# PARKWEST ESTATES PRELIMINARY PLAN

**LEGAL DESCRIPTION:** 27.60 ACRES OUT OF THE  
M.P. ANDERSON SURVEY ABS-27 AND  
THE DAMON SURVEY ABS-170  
WILLIAMSON COUNTY, TEXAS

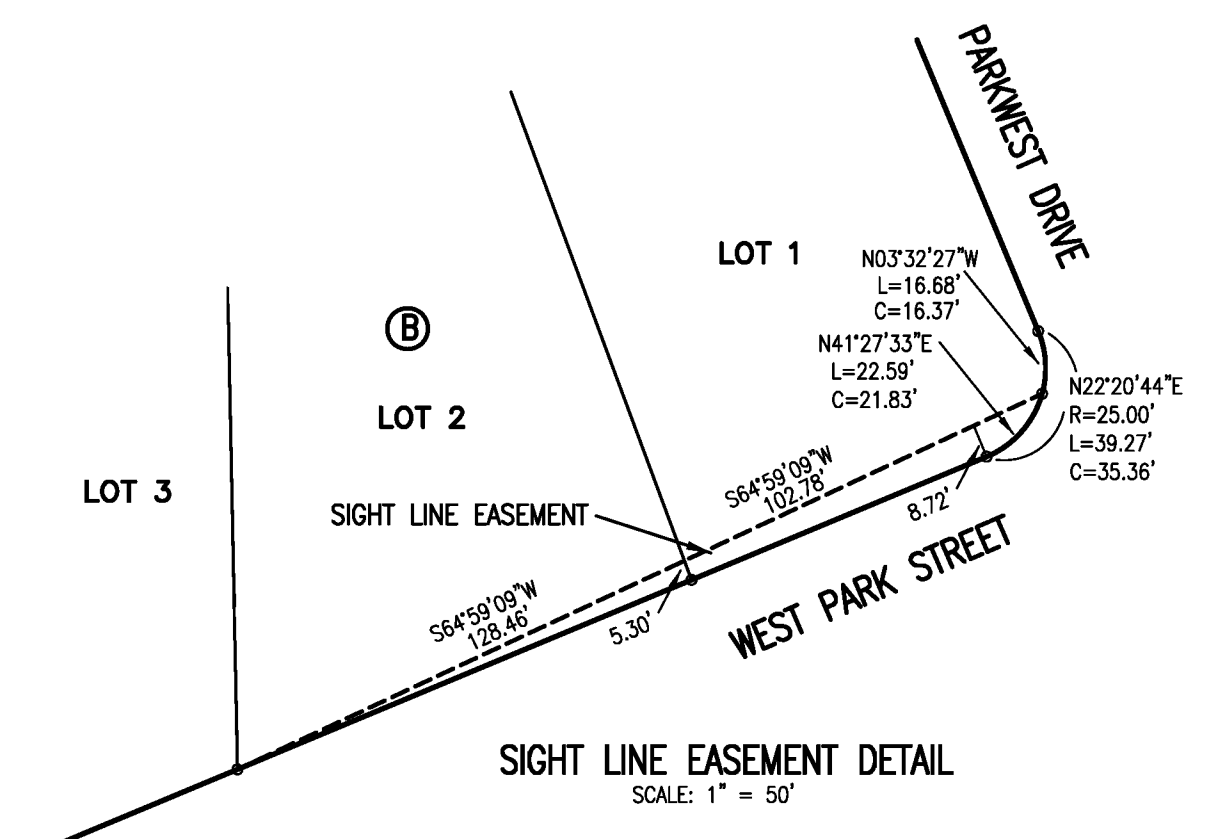
REVISION  $\Delta$   
REDUCE LENGTH OF CLEAR SHADOW COVE TO ELIMINATE GAS EASEMENT CROSSING.  
DELETE ONE LOT
